Addendum 5

December 2, 2022

SUCF 081058-00 Upgrade Elevators - Campus Wide at SUNY New Paltz, 1 Hawk Dr.
New Paltz, NY 12561

Prepared by MDSzerbaty Associates 307 Seventh Avenue, Suite 1501, New York, NY 10001 and
IAQ Systems Inc., 555 Eighth Avenue, Suite 1502, New York, NY 10018

P7
CSB-A102

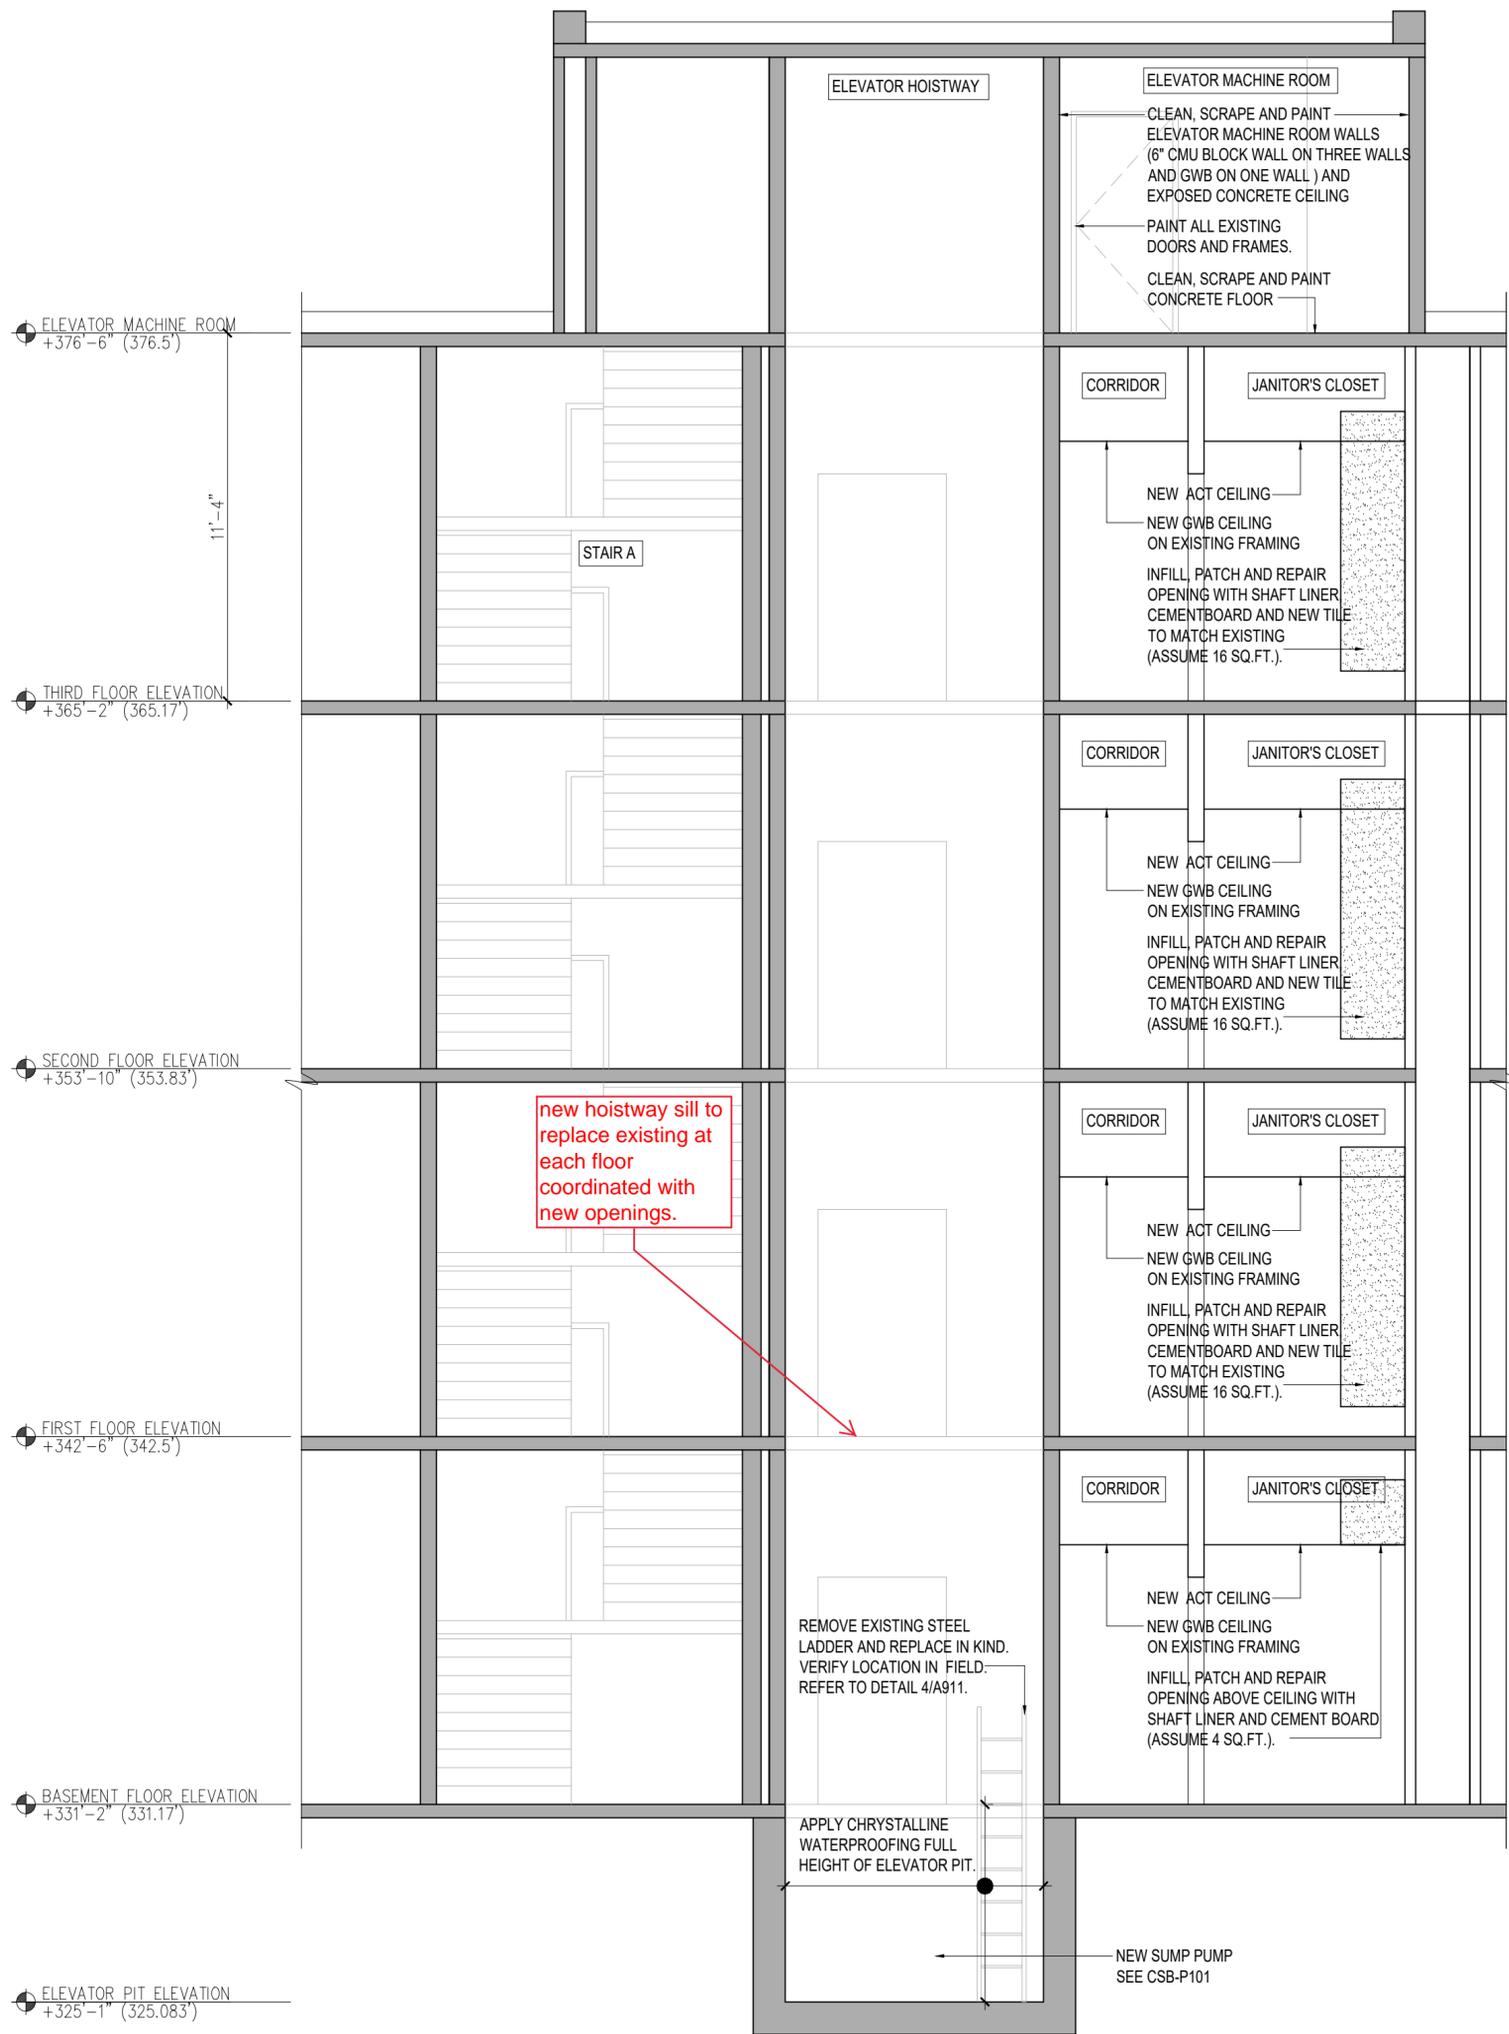
Add note on attachment 1.

SCRAPE AND CLEAN EXISTING ELEVATOR HOISTWAY DOOR FRAMES AND PROVIDE NEW ELECTROSTATIC PAINT FINISH TO MATCH EXISTING COLOR, TYP FOR BUILDING

FINISH OF NEW HOISTWAY DOORS TO MATCH EXISTING, TYP FOR BUILDING

P9
SAB-A102

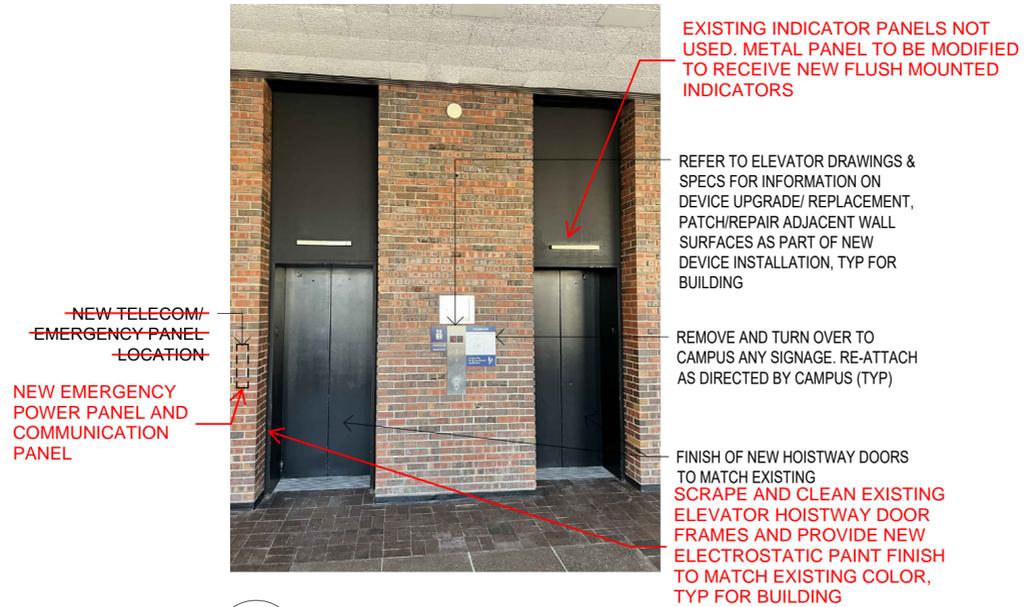
Add note on attachment 3.

SCRAPE AND CLEAN EXISTING ELEVATOR HOISTWAY DOOR FRAMES AND PROVIDE NEW ELECTROSTATIC PAINT FINISH TO MATCH EXISTING COLOR, TYP FOR BUILDING

P5 1ST FLR ELEVATOR LOBBY
HAB-A102 SCALE: NOT TO SCALE

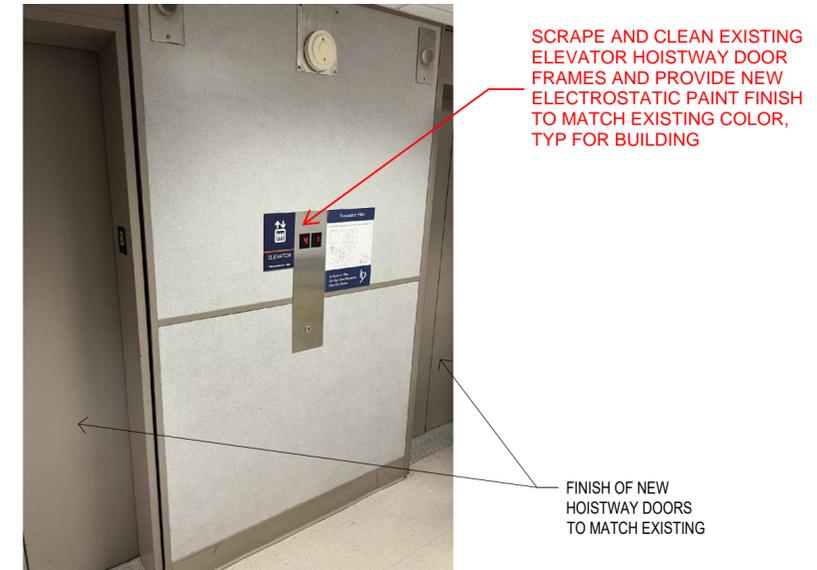
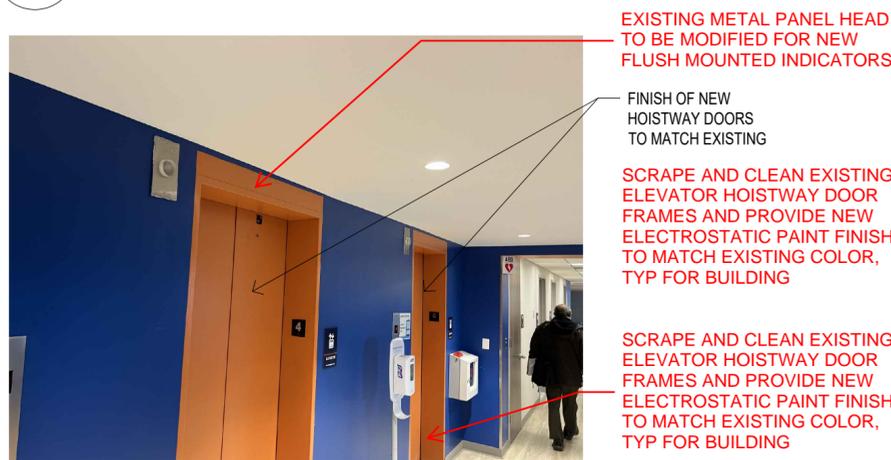
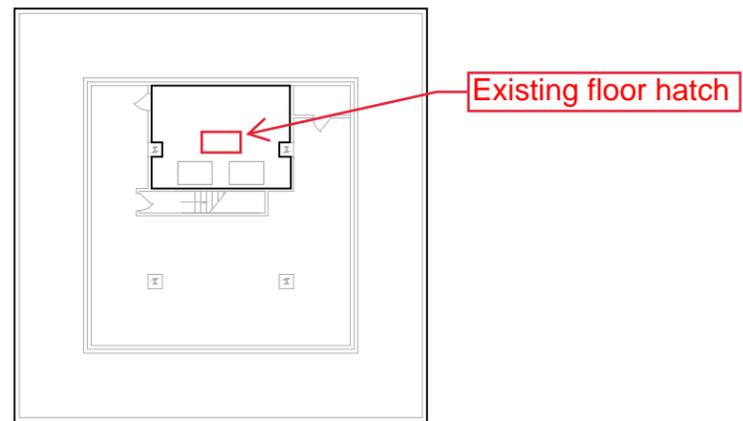
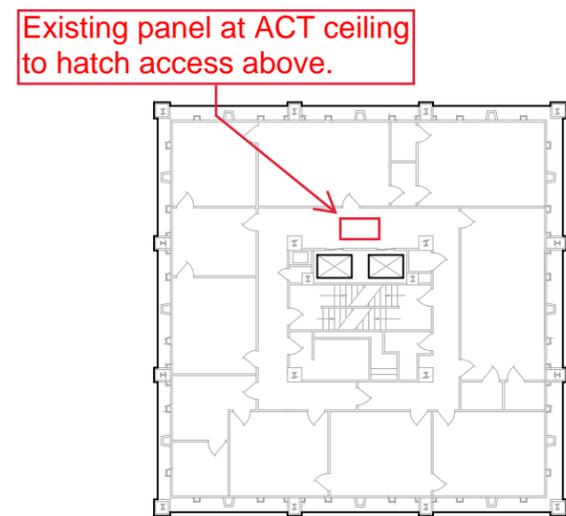
Add and replace notes on attachment 4.

11 ELEVATOR MACHINE ROOM LOCATION PLAN
 HAB-A501 SCALE: 1/32" = 1'-0" FLOOR ELEVATION: 443'-8"

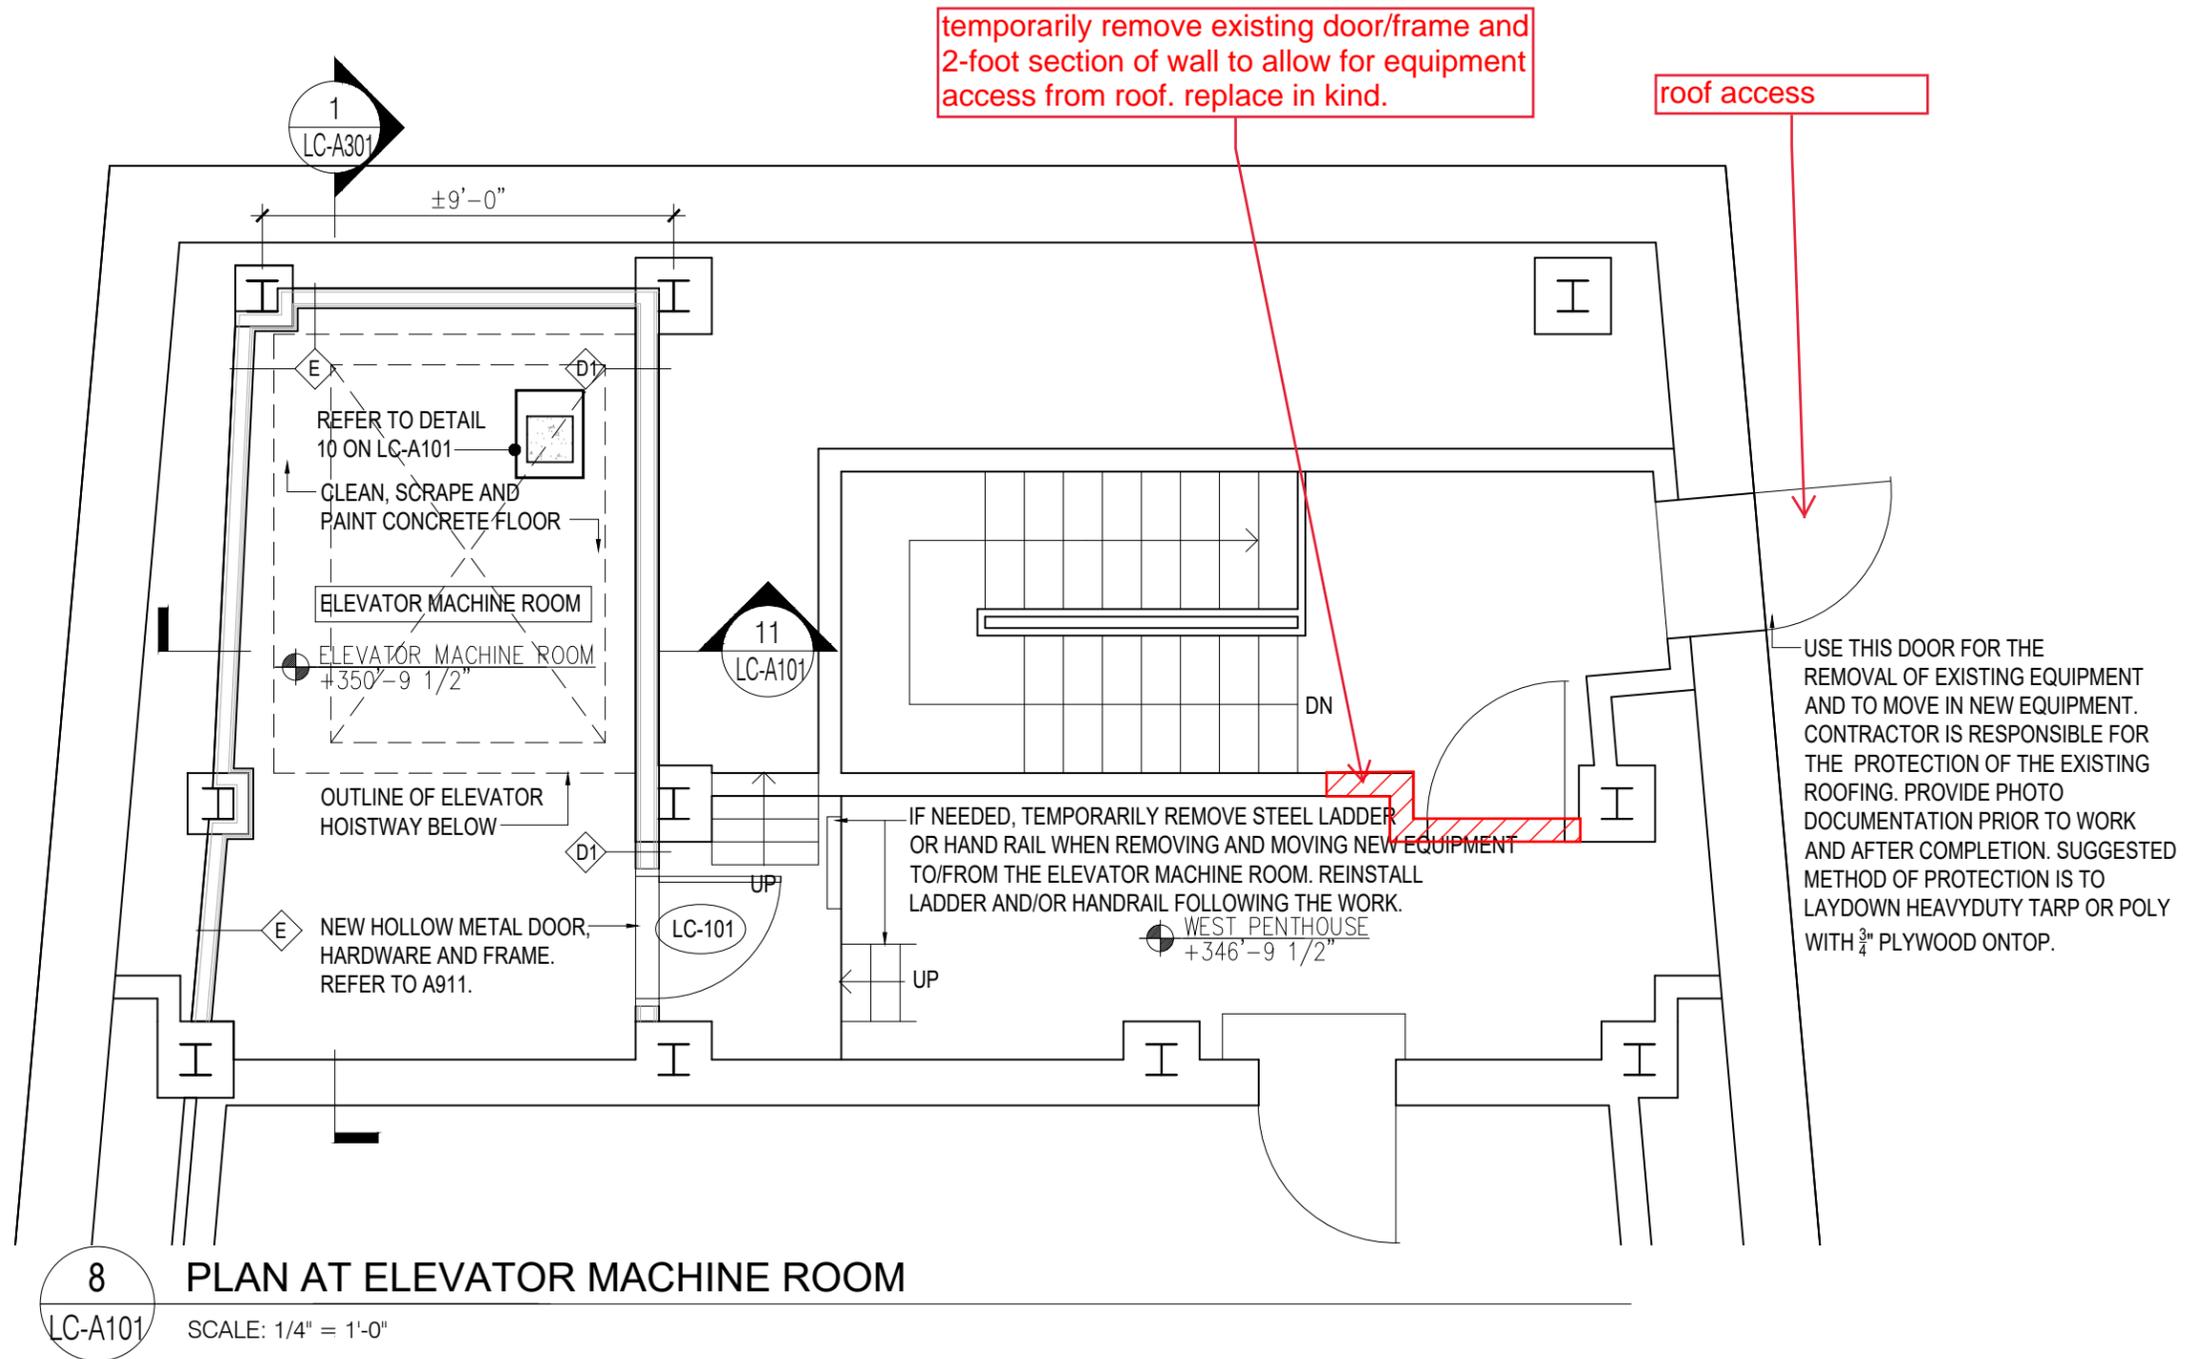
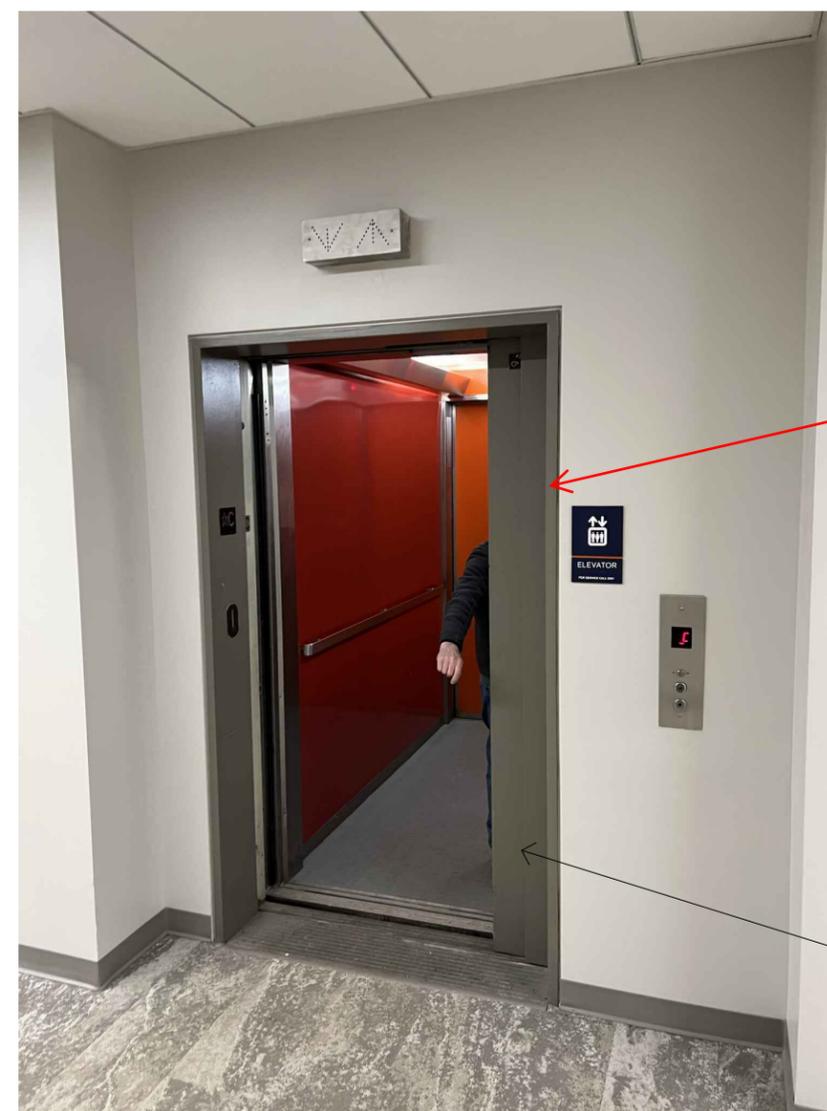
Add notes on attachment 5.

Surface mounted indicators to be replaced with flush mounted per specs, typ.

1 CSB BASEMENT POWER PART PLAN
SCALE: 1/4"=1'-0"

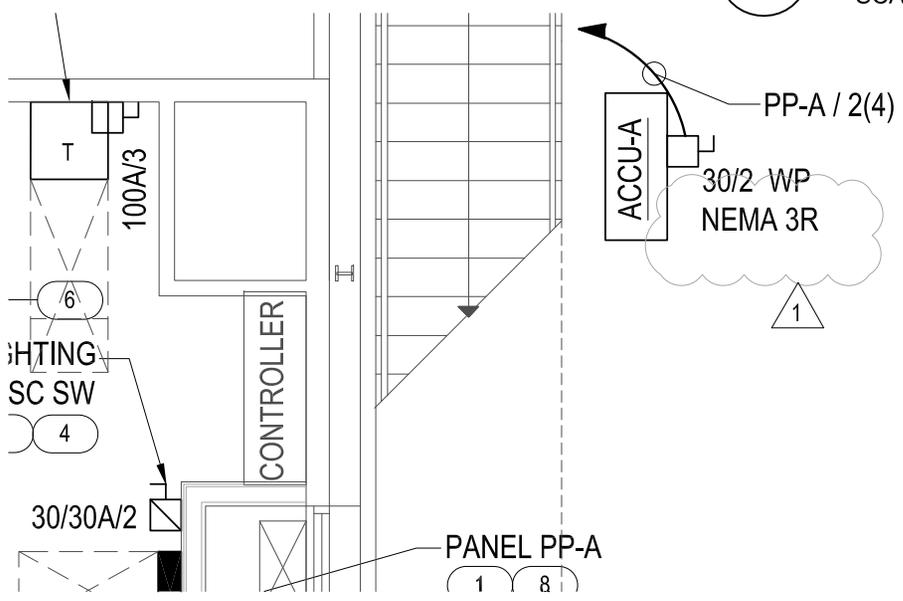
Revise drawing 1 as shown on drawing 1 on attachment 11.

Revise drawing 2 as shown on drawing 2 on attachment 11.

SAB BASEMENT POWER PART PLAN

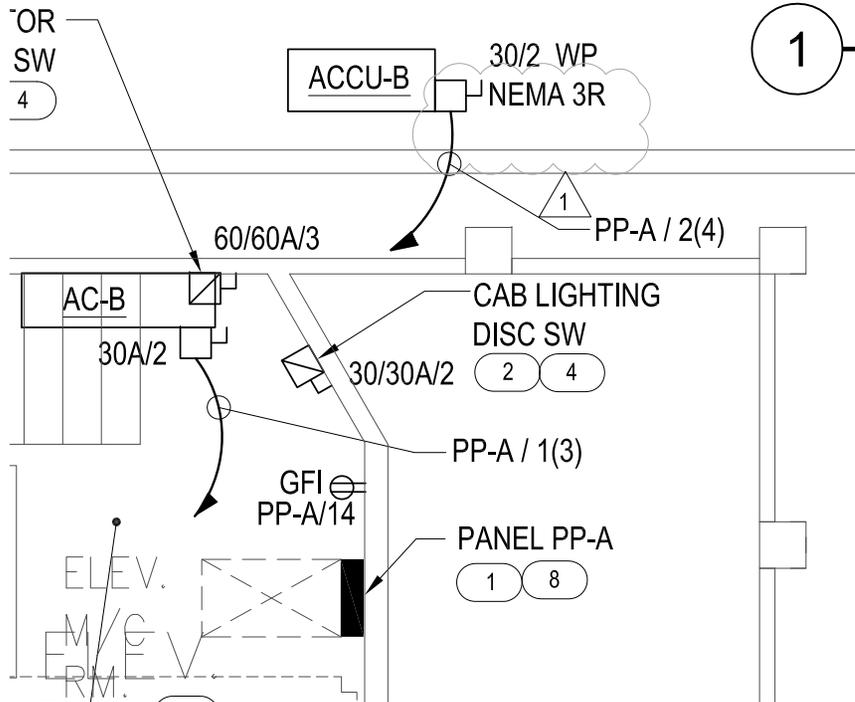
Revise drawing 1 as shown on drawing 1 on attachment 13.

Revise drawing 2 as shown on drawing 2 on attachment 13.

2 HAB PENTHOUSE POWER PART PLAN
SCALE: 3/8"=1'-0"

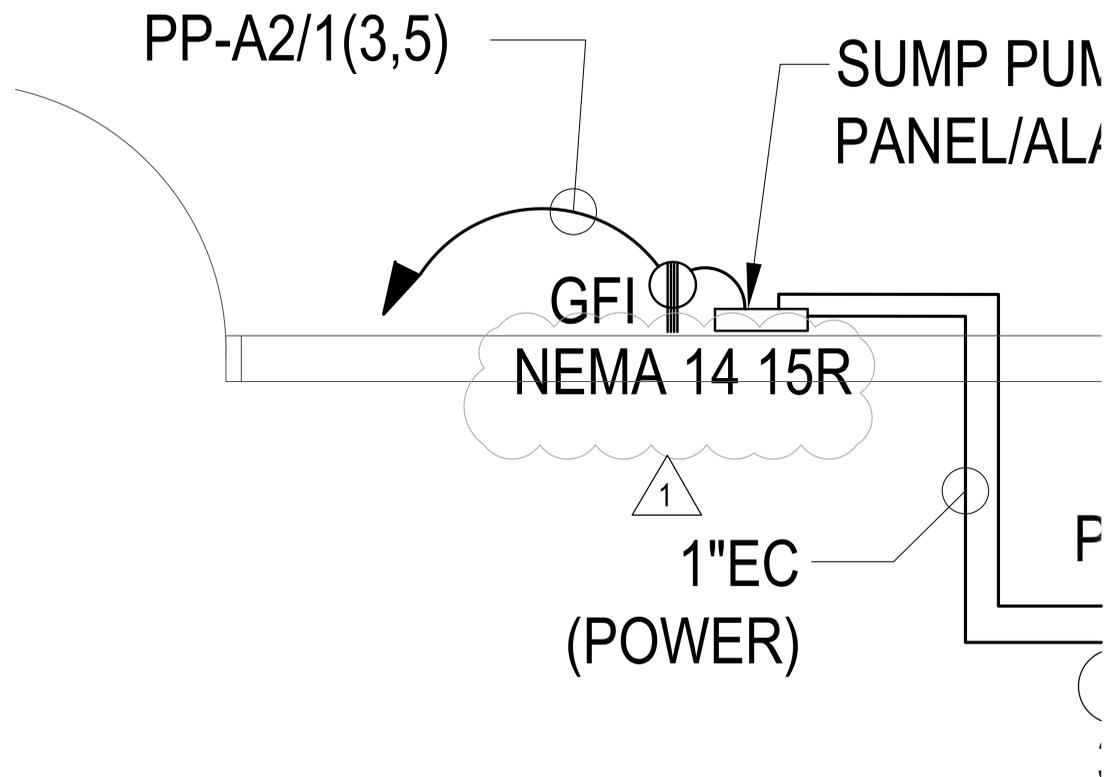
Revise drawing 1 as shown on drawing 1 on attachment 15.

Revise drawing 2 as shown on drawing 2 on attachment 15.
